APPLICATION NO.	FILING DATE	FIRST NAMED INVENTOR	ATTORNEY DOCKET NO.	CONFIRMATION NO.
09/926,120	09/19/2001	Alexander Beckmann	P67117US0	6123

Office Action Summary

DETAILED ACTION

FIG. 3

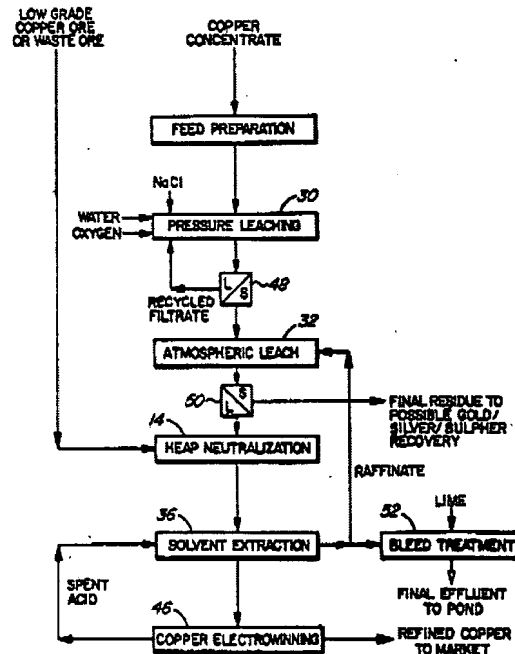
Jones teaches a hydrometallurgical process as shown in Figure 3 below:

Regarding Claims 16 and 17, it would have been obvious to one with ordinary skill in the art at the time the invention was made that the further leaching process in Vizsolyi in view of Campher and applicant's admitted prior art would involve the steps taught by Jones, since Jones teaches economically recovering copper from very low grade ore (column 14, lines 11-15). Jones shows in Figure 3 that copper is recovered separately from gold/silver and sulfur.

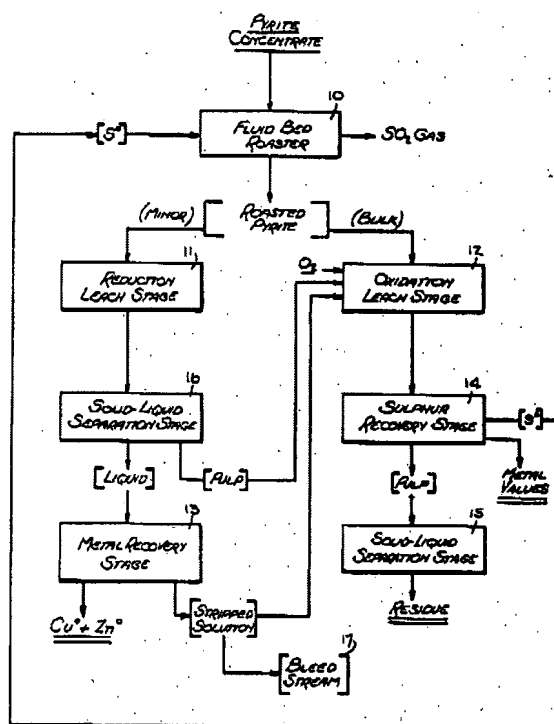
Regarding Claim 22, Pepper et al (US 4,177,067) teaches recovering silver, copper, and zinc from pyrite concentrates as shown below in the figure.

Zinc, silver, and copper are recovered for extraction (column 4, lines 60 and 61). The sulfur is recovered in stage 14. Tranquilla (US 6,074,533) teaches controlling microwave energy distribution in the reaction chamber of a fluidized bed reactor (abstract). It would have been obvious to one with ordinary skill in the art at the time the invention was made that the fluidized bed reactor in Pepper would use microwave energy, since Tranquilla establishes that using microwave energy with fluidized beds is well known (column 1, lines 48-52). Tranquilla also teaches that when metal-bearing ores or concentrates are treated with microwaves, the ore or concentrate becomes more amenable to leaching (lines 34-38). However, Pepper does not teach or suggest converting the ore to both covellite and pyrite, namely CuS (as defined by the applicant on page 2, line 13) during the roasting step. The roasting step in Pepper produces CuSO₄ (Pepper, column 3, line 60).
